Gachsaran Polymer Industries Company PIDMCO	<b>Gachsaran Polymer Industries Company HDPE Plant</b>		
	<b>General Arrangement Drawing (2D) (*Tie-In Points , Skid Dimensions &amp; Orientation, Including Instrument, Junction Box and Local Panel Location Layout &amp; Instrument Cable routing.) for Refrigerator Package</b>	 	Rev. 03
PO No.: GPIC-PT-MA-PO-000-3029	Document Number: VD-GPIC-MA-3029-3029-0062

## General Arrangement Drawing (2D) (\*Tie-In Points , Skid Dimensions & Orientation, Including Instrument, Junction Box and Local Panel Location Layout & Instrument Cable routing.) for Refrigerator Package

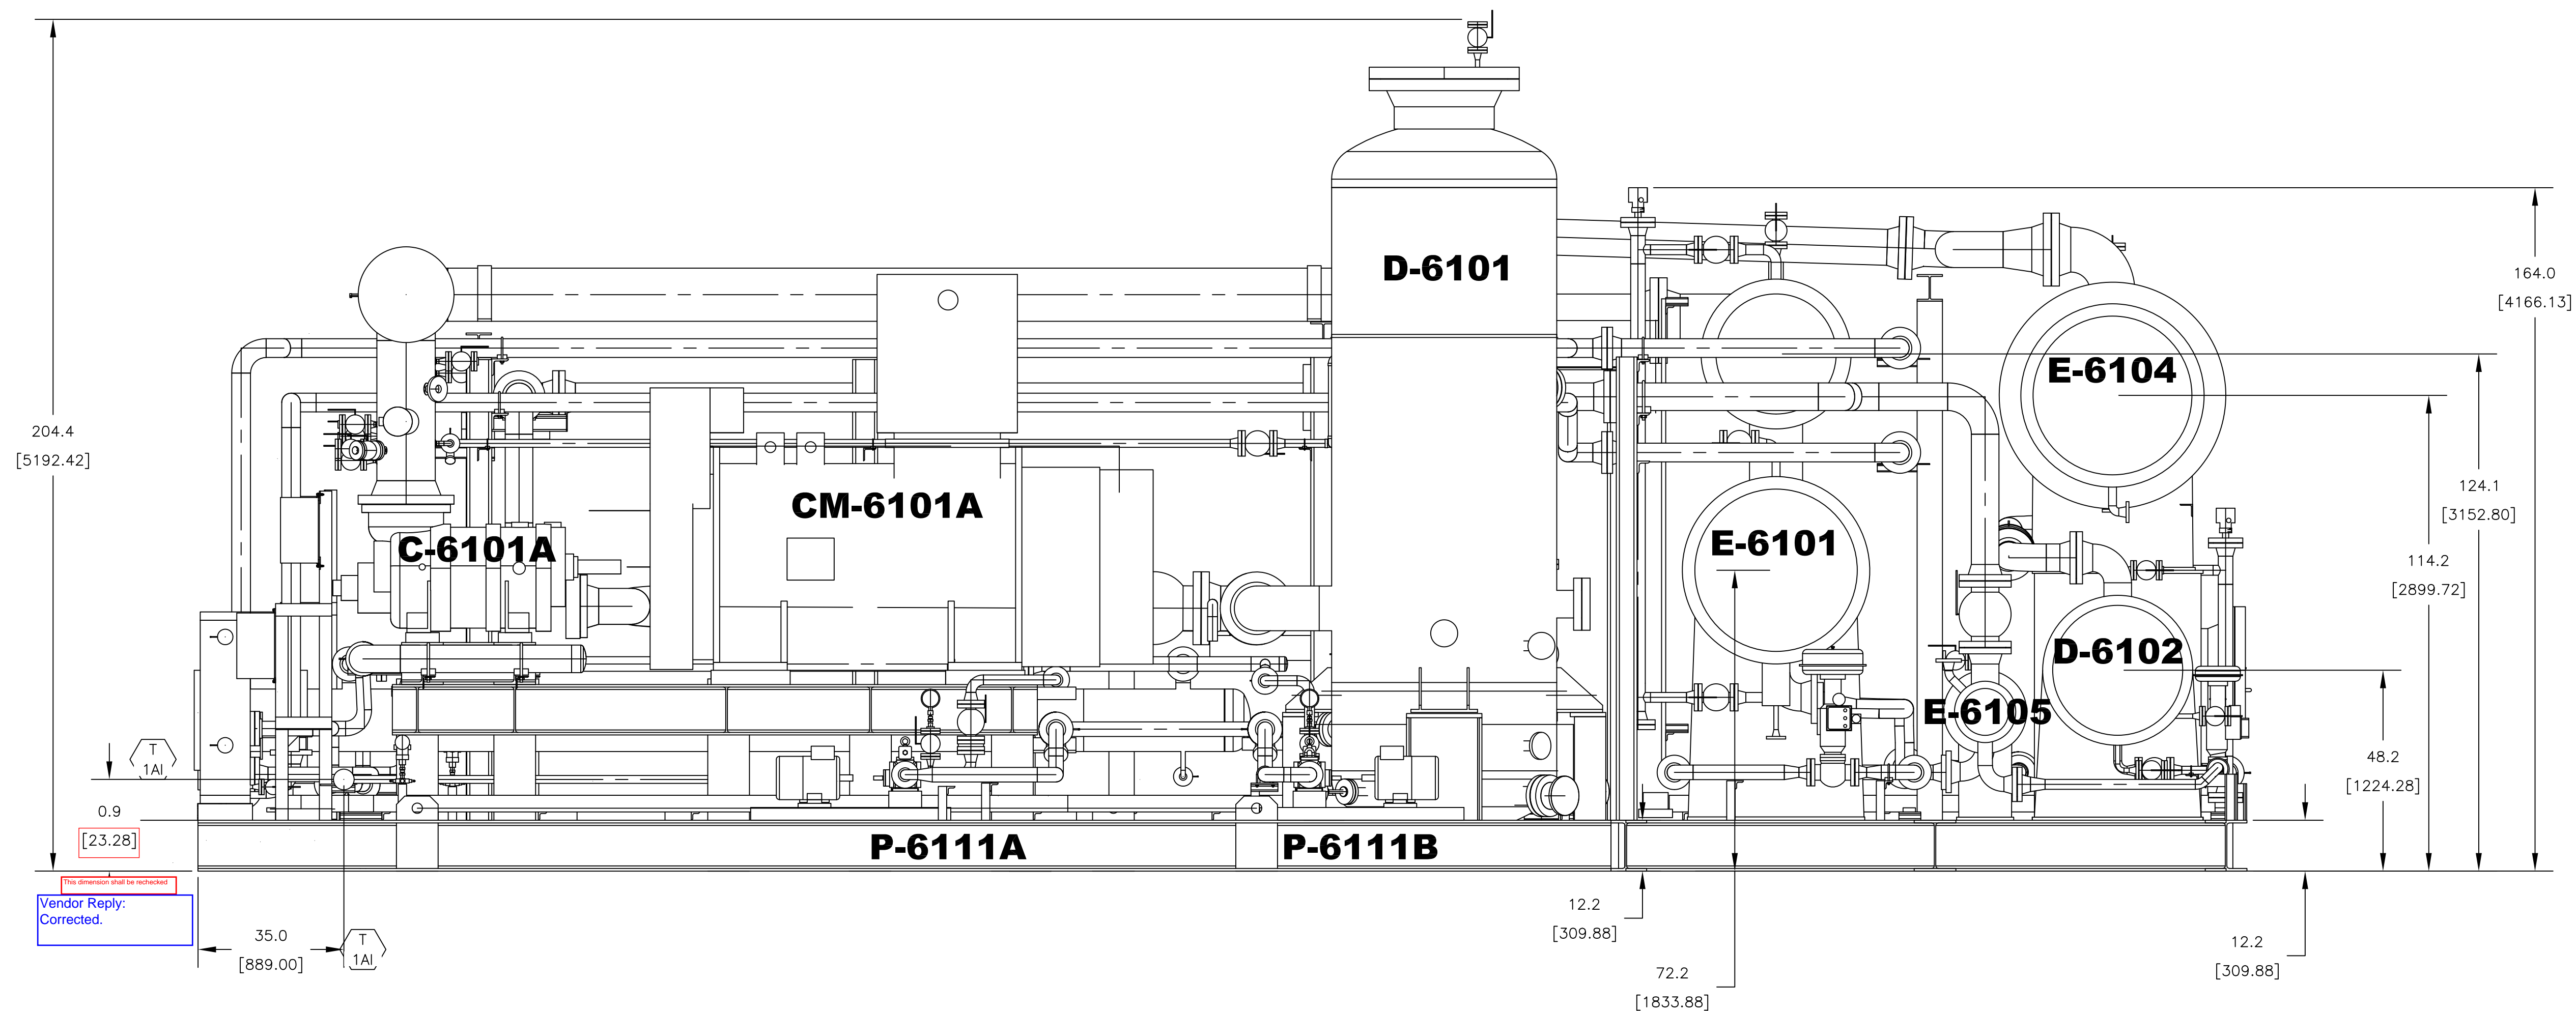
1- repeated comment: Vendor shall specify the "Allowable nozzle loads" table for tie-in points at this document.

2- repeated comment: Fixed(semi-anchor) **pipe supports** shall be considered close to the tie-in connections with EIED.

3- repeated comment: Stress Analysis Report including Caesar II native files for critical pipes inside package shall be provided by vendor.

PI COMMENT:  
 -The customer (EIED) shall provide with the STP and navies file of model.  
 -Since EIED has TI in/out with vendor in this points (S-42,43,44,T-4A) so their locations and distances from reference point shall be specified in views.  
 -Since the direct connection of some lines (Except T-51,T-52,T-4CWS,T-CWS,T-1A,T2A) that are in boundary skids may cause clashes with the lines inside the package, the TI in/out shall be specified in boundary skids.

**please specify the dimensions only in metric unit**

Since compressor has dynamic load, It's better to be located on the independent foundation, to be increased 1000 mm (min)

1- Noted.

2- All tie-in points supports are indeed fixed supports. Please Refer to 3D Model.

3- As we mentioned before PO and refer to TCL item PI-05 conclusion, MAYEKAWA will not provide stress analysis inside the package and the package design is in MAYEKAWA responsibility and guarantee. This procedure is not only for EIED but also for BP,SHELL, ARAMCO,EXXON Mobile,... in worldwide.

Vendor Reply:  
 -STP file and Naviswork file is submitted.  
 -All relief valve connections are allocated in the GA.  
 -Per current design, all tie-in connections are clear and will not cause any clashes.  
 -All lines can be checked using the 3D Model submitted already.

Vendor Reply: At this moment metric dimensions are not possible since the design is already made in ENGLISH units. However, metric dimensions are already included in the design. This is MAYEKAWA format in all projects.

Vendor Reply: Corrected.  
 The reference point is not clear.

Vendor Reply:  
 It is client responsibility design the foundation.  
 MAYEKAWA advise that Client could have single foundation under all skids. It depends on Client design.
